ADDENDUM

PROJECT:	Moon Block / National Willa Cather Center Phase 2	PROJECT NO.	M06047
FROM:	BVH Architects	DATE:	19 March 2015
TO:	All Bidders	ADDENDUM NO.	2

ASD02.1

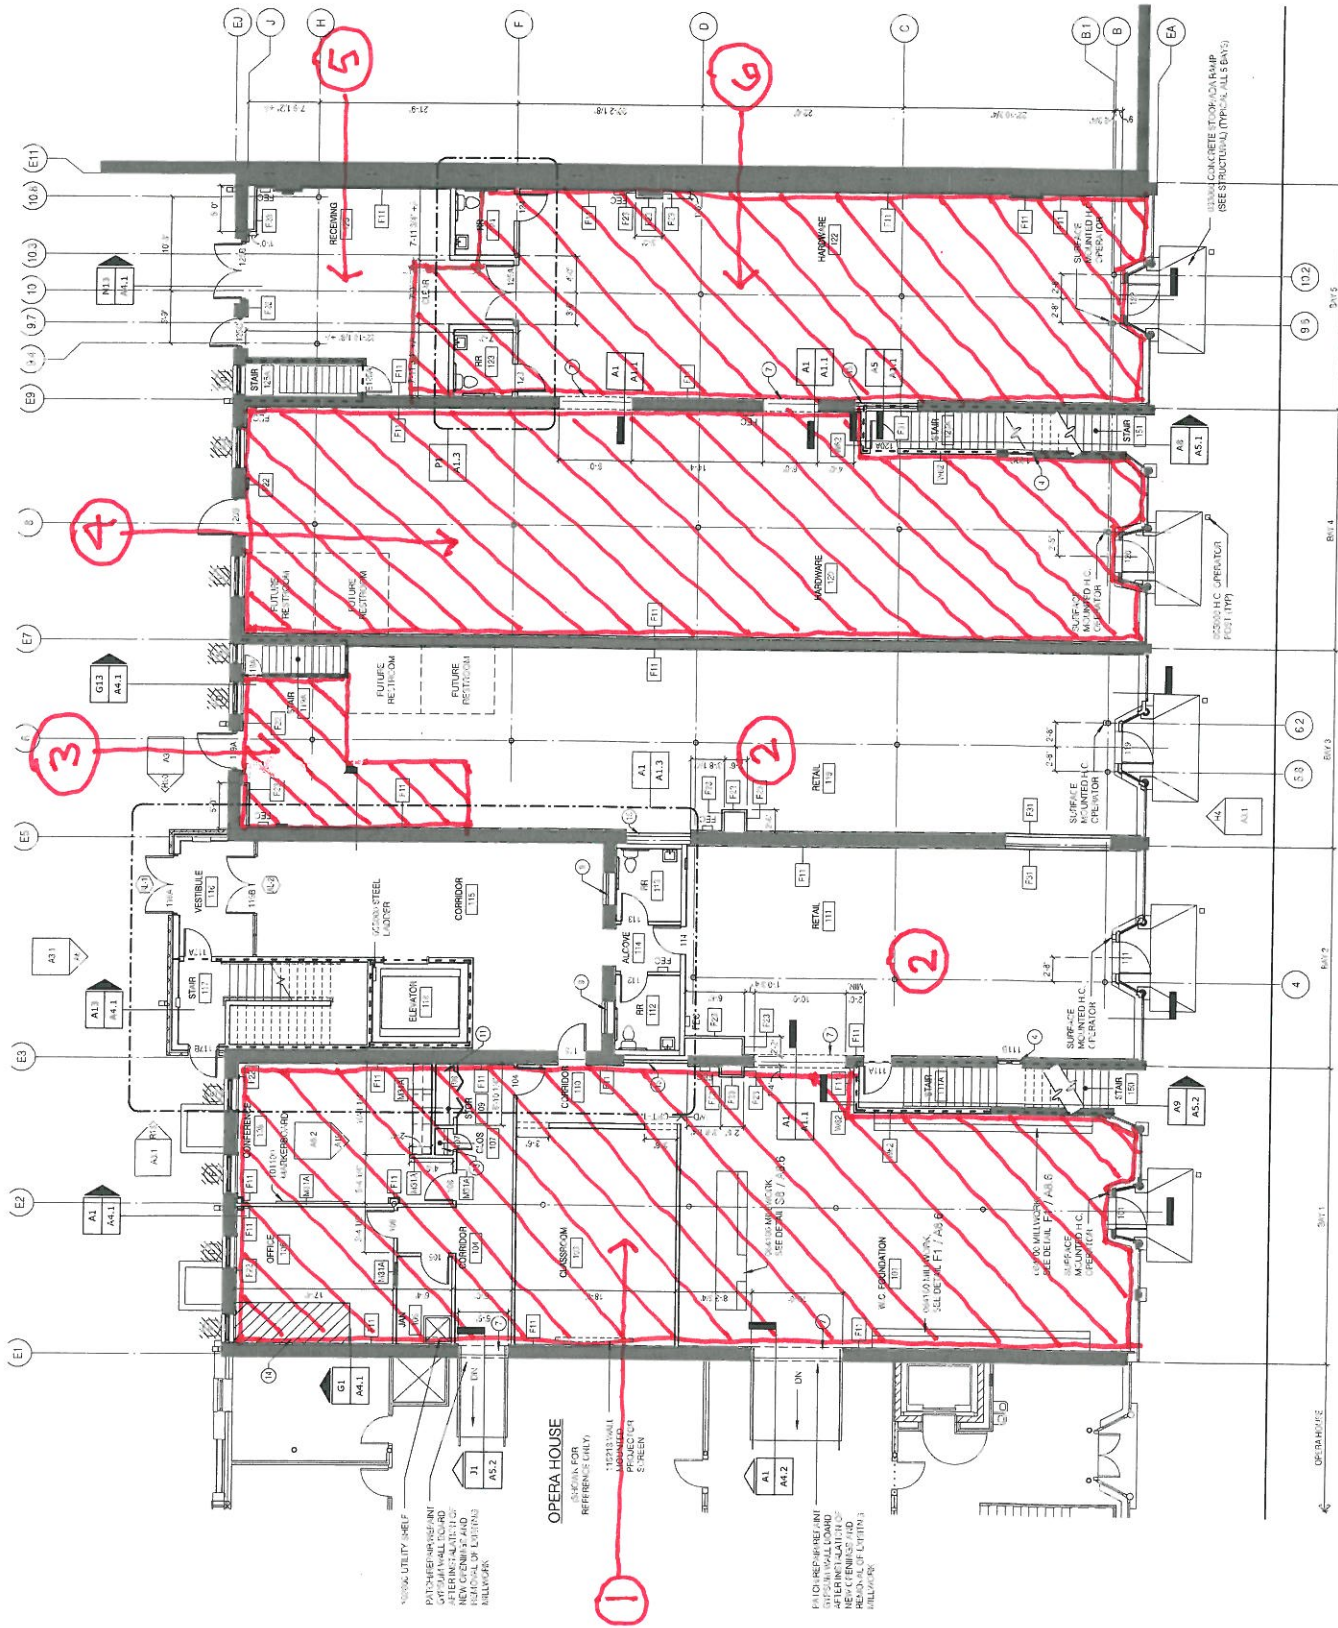
- 16. Sheet A1.1.
 - a. See attached drawing ASD-02.1 for clarifications related to existing 1st Floor floors. Hatched areas on attached drawing are approximate. Contractor to field verify exact extents.

- 1. Keynote 1: Remove all layers of existing flooring, down to the original historic base layer of flooring. Patch / Repair / Replace original historic base layer of flooring to match original.

- 2. Keynote 2: Existing Pine flooring to remain. Patch / Repair to match existing.
 - 3. Keynote 3: Remove existing plywood floor. Replace with new Pine flooring to match existing adjacent pine flooring.

- 4. Keynote 4: Base Bid – Patch / Repair / Replace original historic flooring as required. Match existing. Alternate #2 – Remove existing original historic flooring complete. Replace with new to match original.

- 5. Keynote 5: This area of flooring was replaced as part of Phase 1 construction.
 - 6. Keynote 6: Base Bid – Patch / Repair / Replace original historic flooring as required. Match existing. Alternate #2 – Remove existing original historic flooring complete. Replace with new to match original.

A10 FIRST FLOOR PLAN

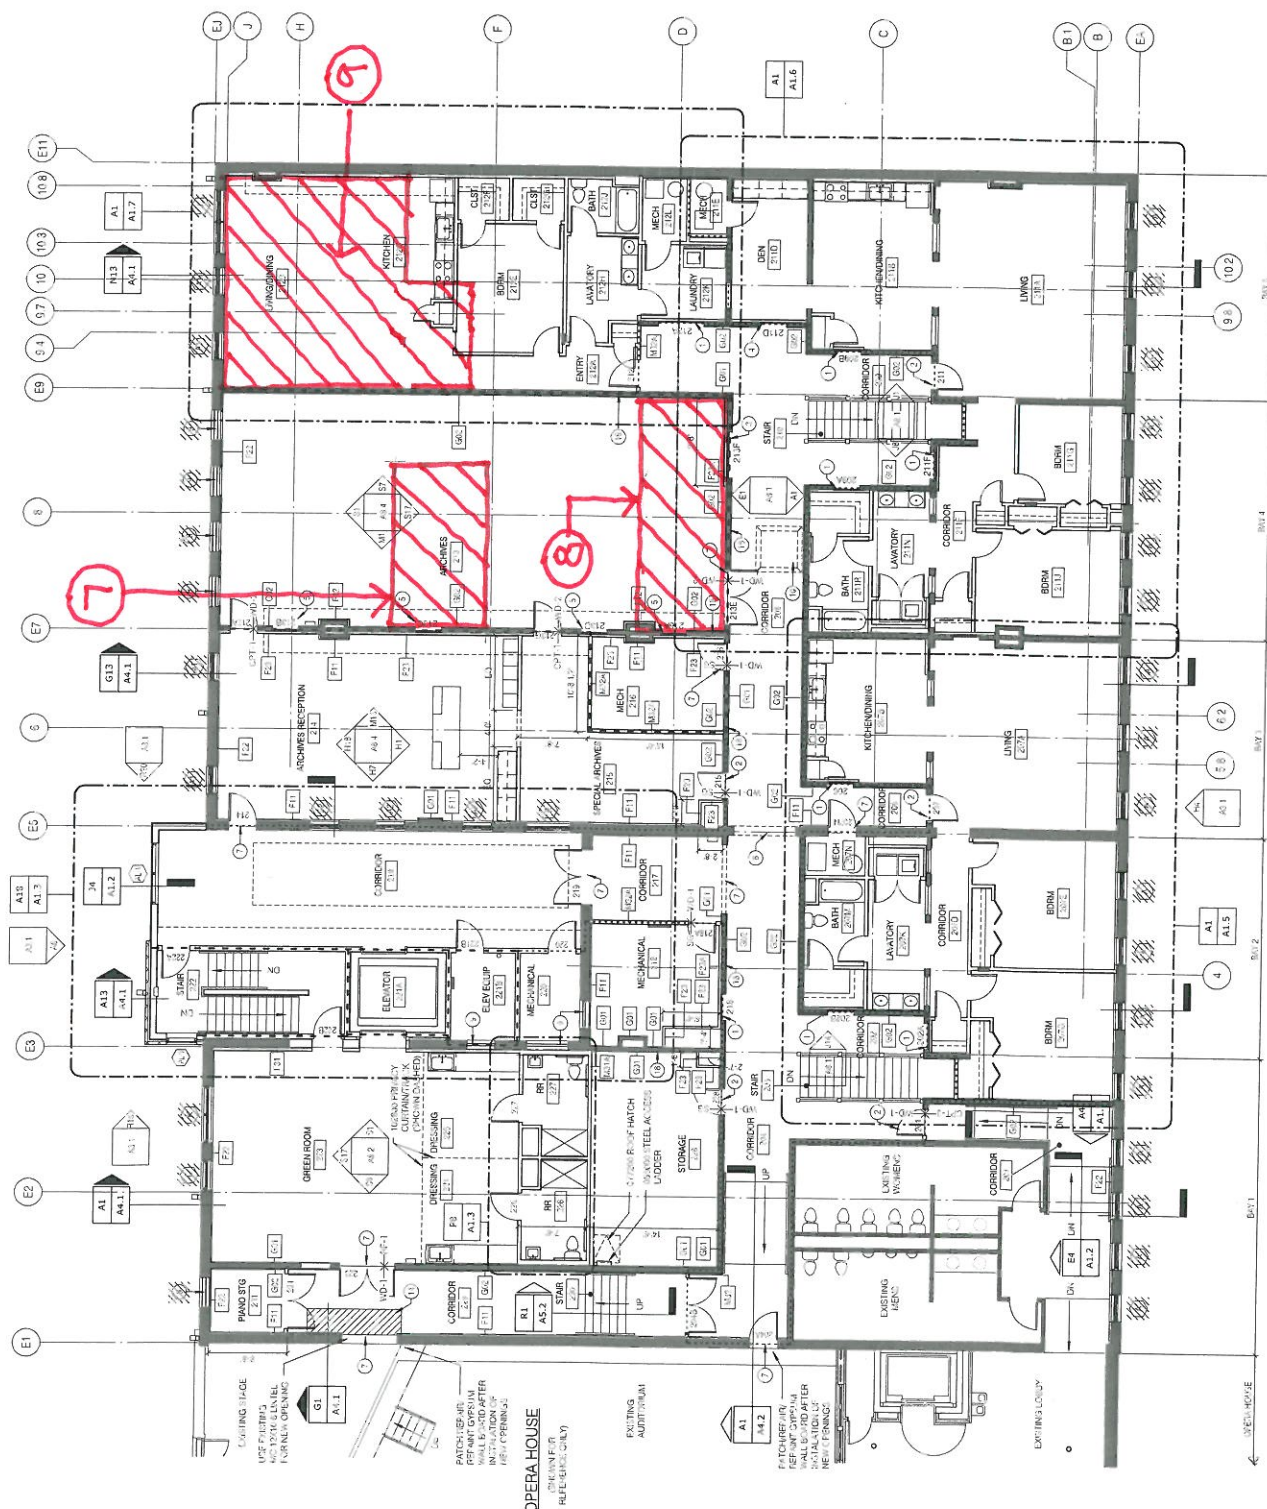
- 17. Sheet A1.2.
 - a. See attached drawing ASD-02.2 for clarifications related to existing 2nd Floor floors. Hatched areas on attached drawing are approximate. Contractor to field verify exact extents.

- 1. Keynote 7: Remove existing water damaged / deteriorated 3" (nominal) finish floor and 5" (nominal) subfloor. Replace damaged floor joists per "Existing Work" notes 1 – 6 on sheet S0.0. Replace subfloor layer with plywood of matching thickness. Replace existing 3" (nominal) finish floor to match existing adjacent finish floor.

- 2. Keynote 8: Install new 3" (nominal) finish floor in this area to match existing original adjacent finish floor.
 - 3. Keynote 9: Remove temporary plywood installed in Phase 1 construction. Install new 5" (nominal) finish floor in this area to match existing original adjacent finish floor.

M2.0a

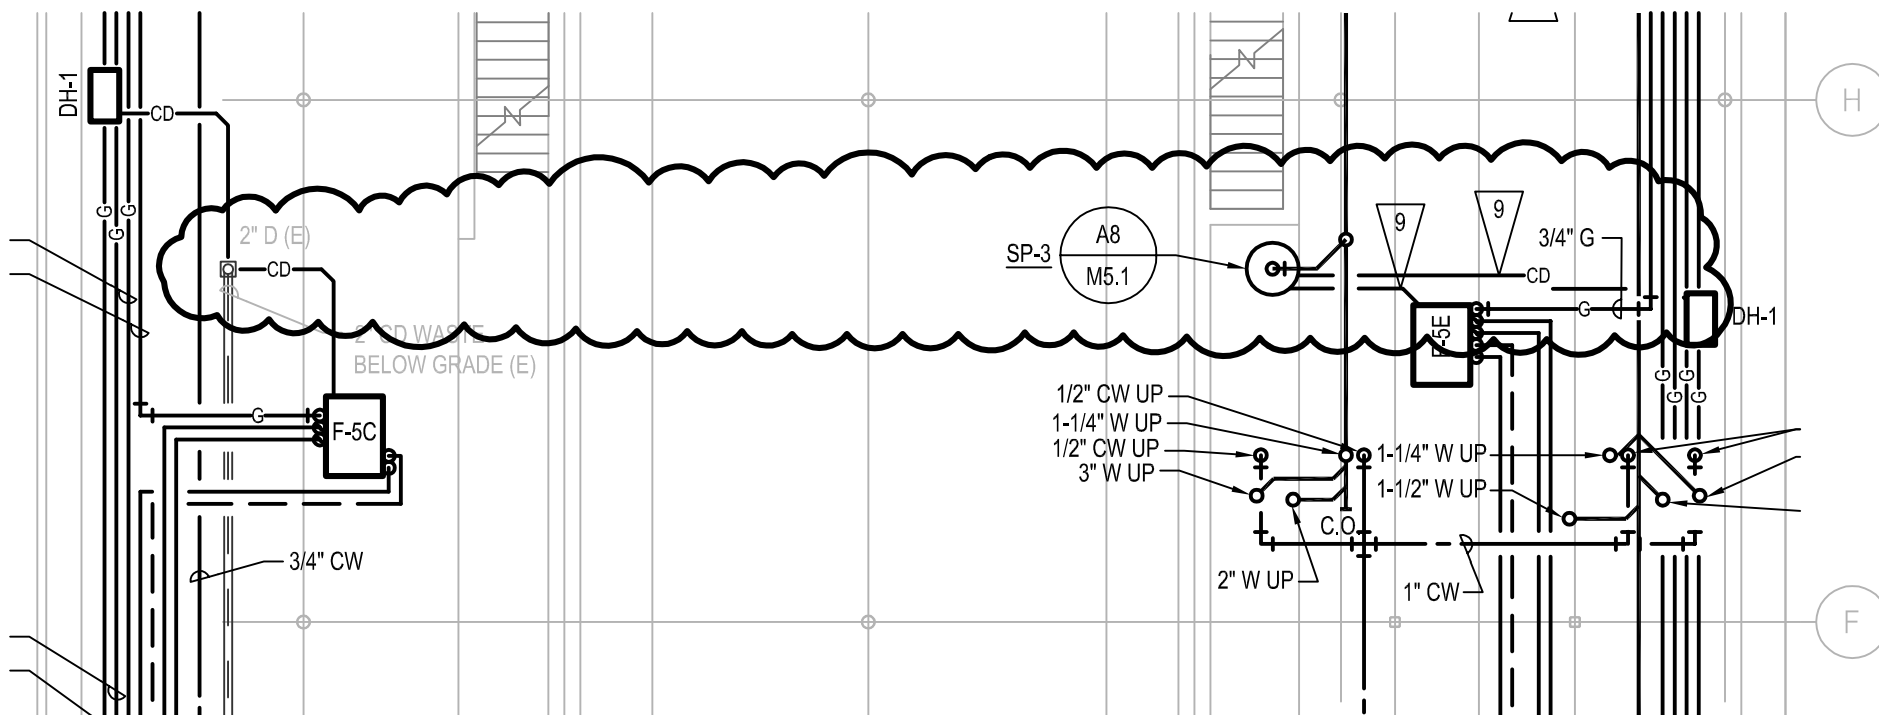
- 1) Sheet M2.0 – Basement piping plan
 - a. Add 2 sump pits and sump pumps (SP-3) in crawlspace 004 and 005.
